TECHNICAL SERVICE BULLETIN

2.7L EcoBoost - Oil Pan Leaking - Built On Or Before 21-May-2019

19-2189
06 August 2019

Ford 2018-2019 F-150

Figure 1

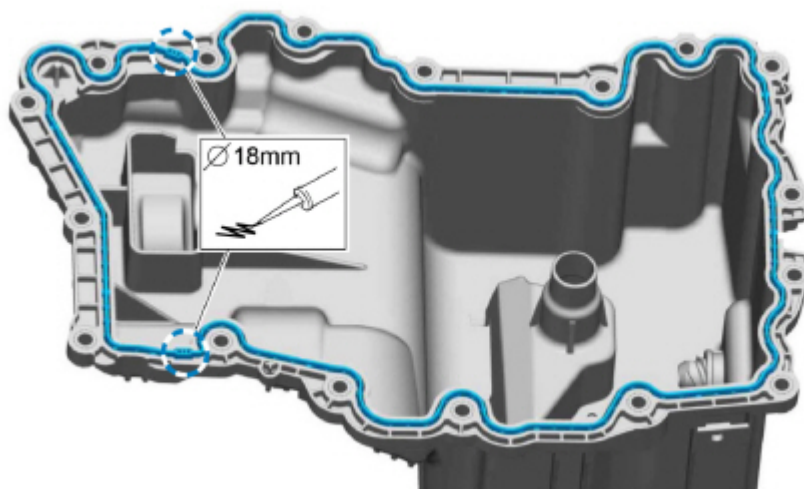
4. Apply a 18 mm (0.708 in) bead of Motorcraft® High Performance Engine RTV Silicone to the engine front cover-to-cylinder block joint areas on the oil pan. (Figure 1)

NOTE: The new oil pan does not require the use of Motorcraft® High Performance Engine RTV Silicone in any other location.
